BRC Response to Comment (RTC) to NDEP's Comments Dated July 6, 2007 on the CAMU CSM

Corrective Action Management Unit (CAMU)
BMI Complex, Henderson, Nevada

FIGURE A-1

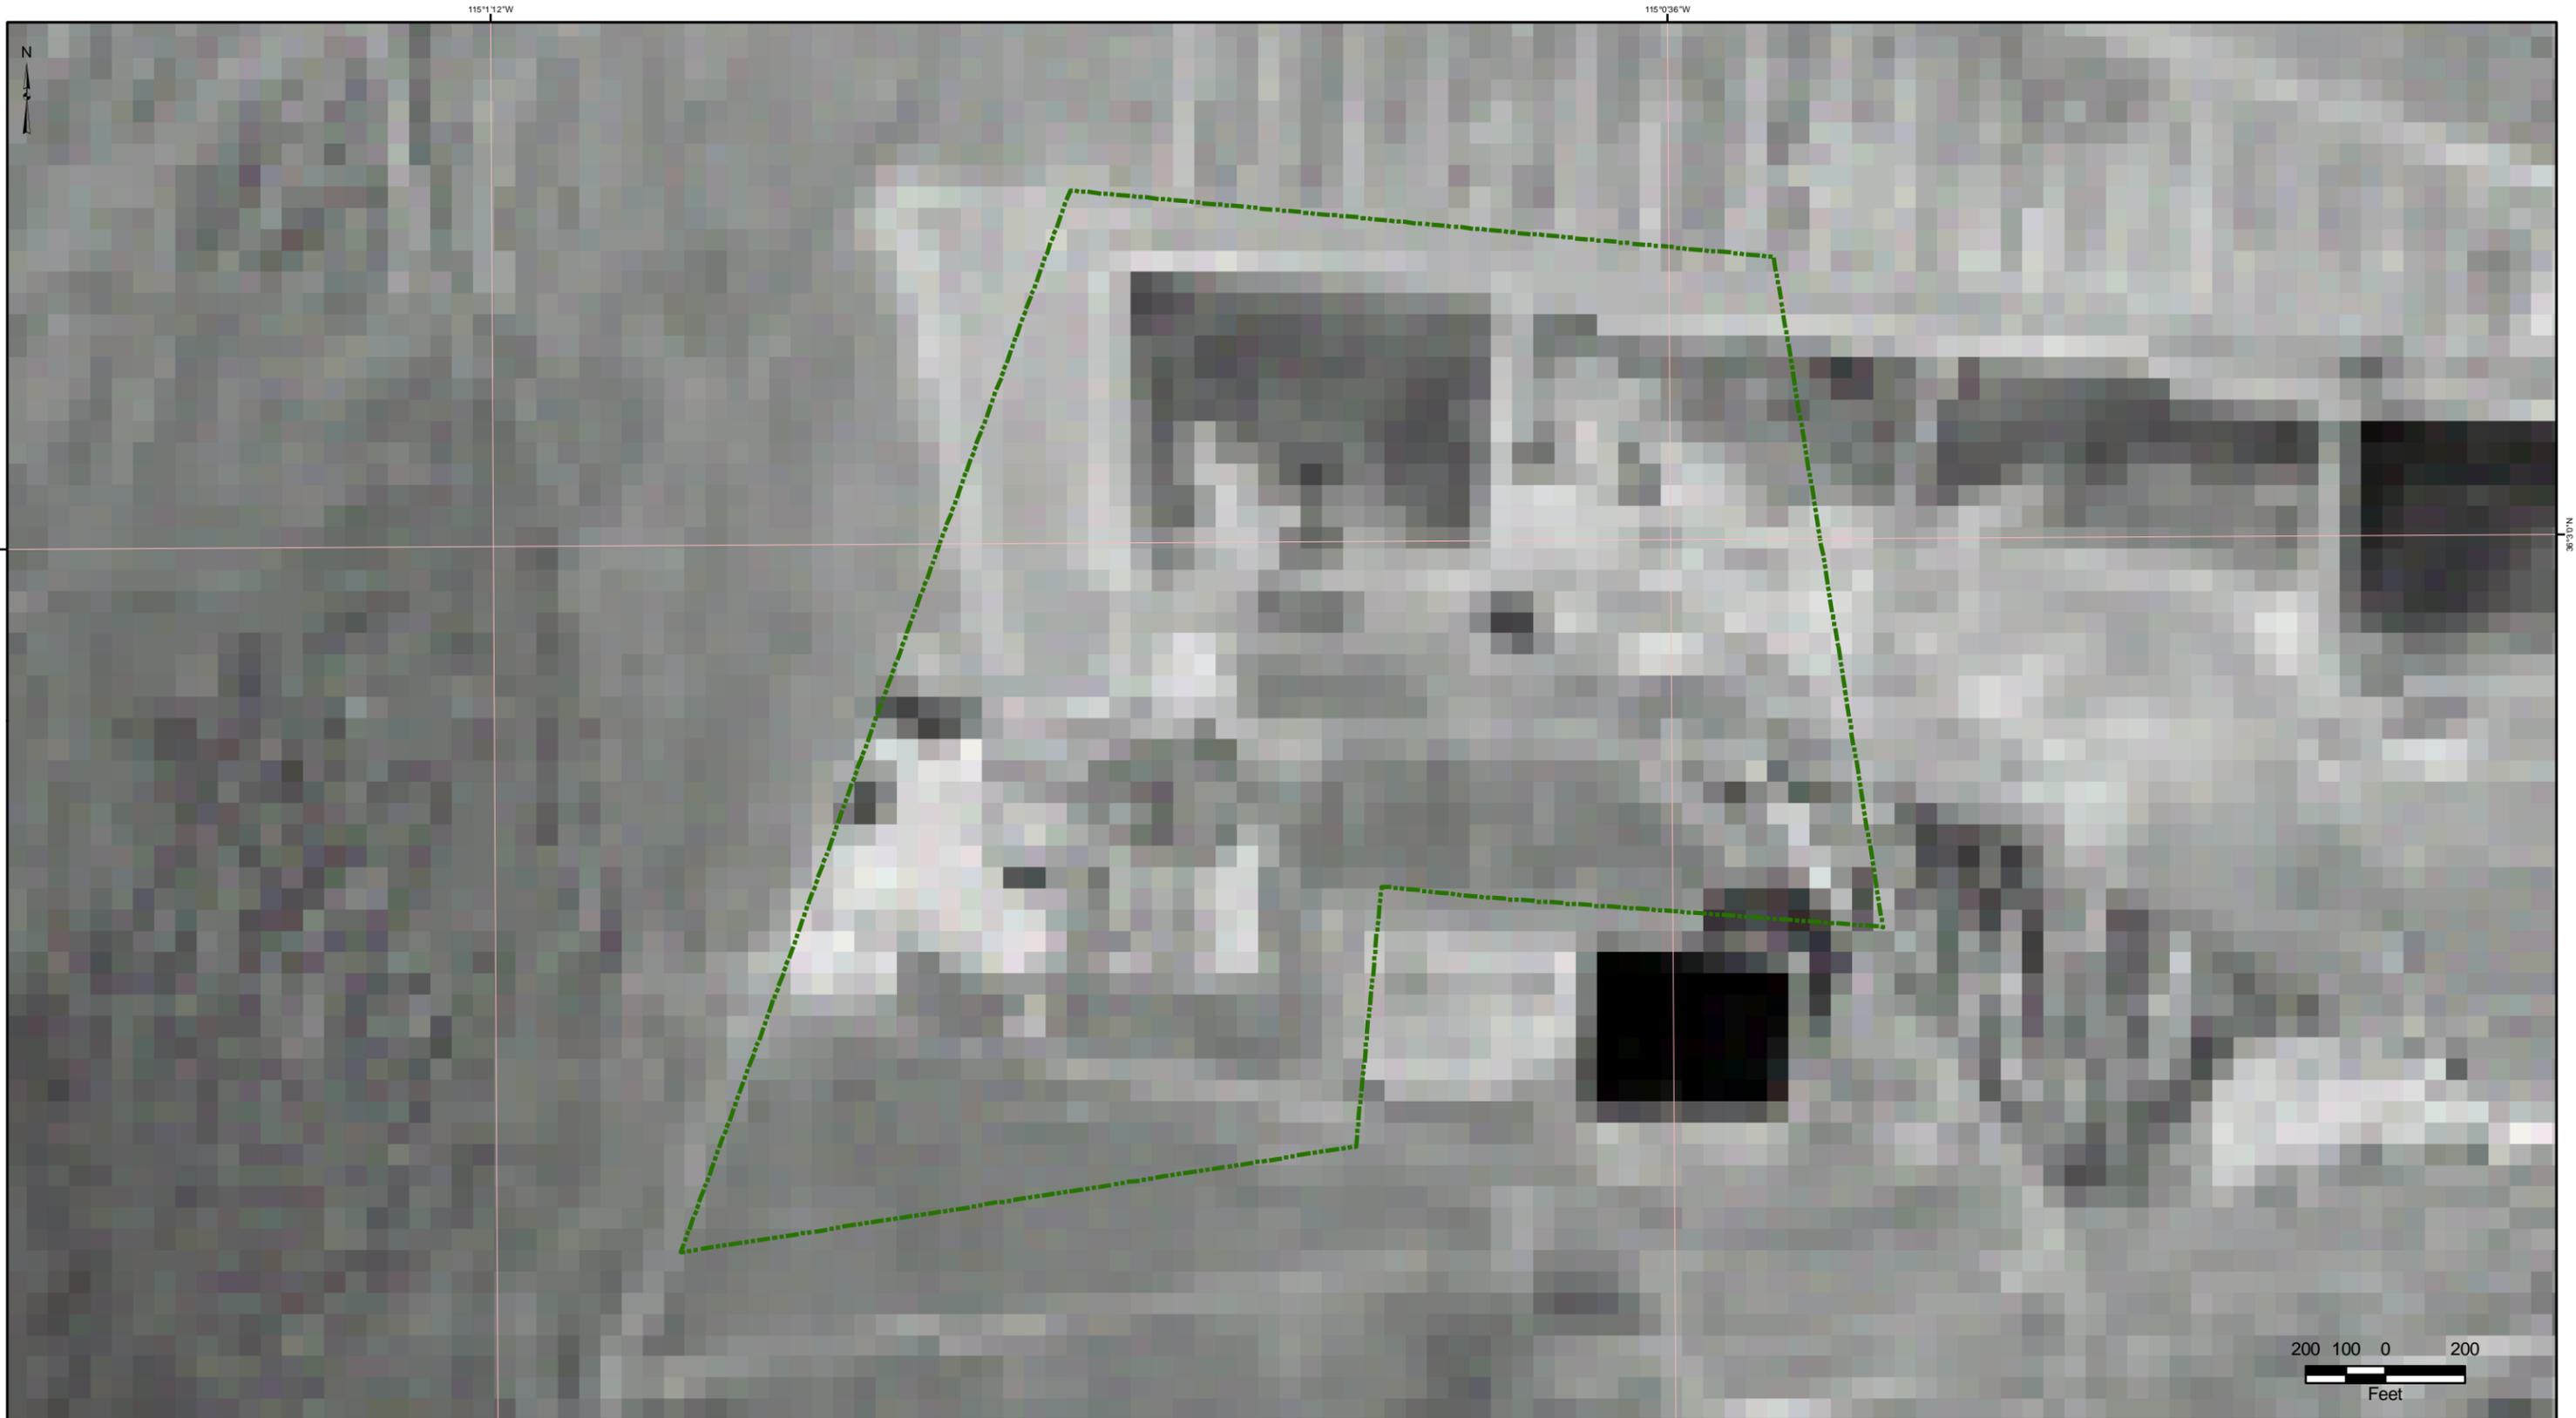
- b. RTC 20, please provide copies of the referenced aerial photographs to the NDEP at this time.

Response: The requested aerial photograph figures are provided in Attachment A to this RTC.

FIGURE 8-1

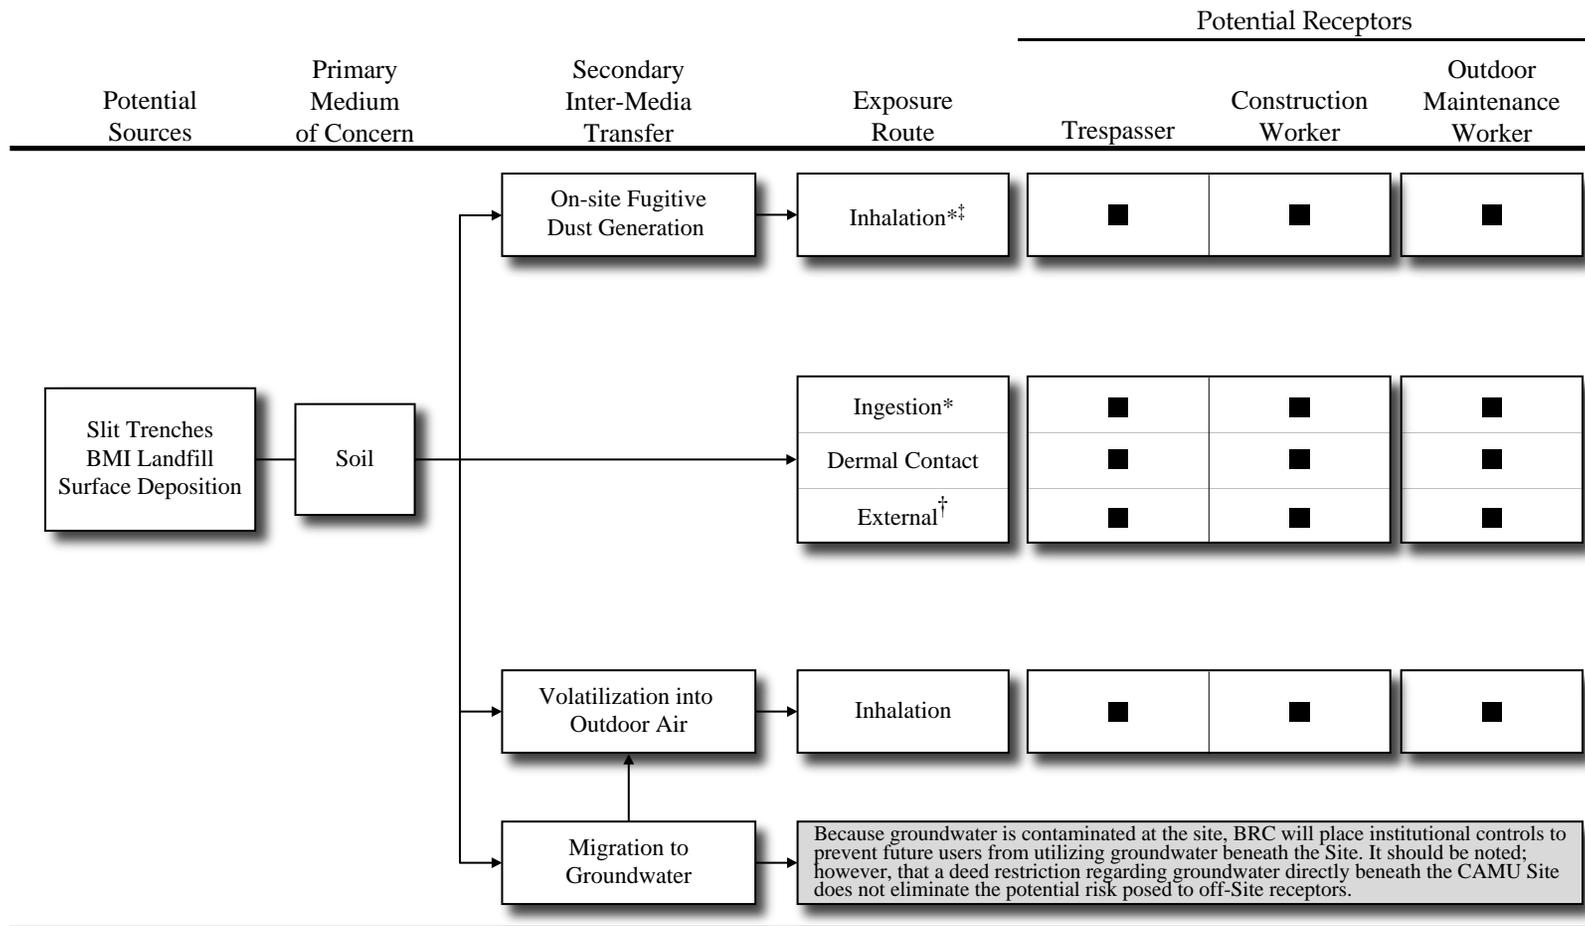
- c. Figure 8-1, Migration to Groundwater – the box representing Exposure Route and Potential Receptors is not accurate for groundwater as it will migrate off-site; this was

highlighted in the NDEP's previous comment #44. Please revise and resubmit this Figure at this time.

Response: Figure 8-1 has been revised to reflect this comment. It is provided in Attachment B to this RTC.
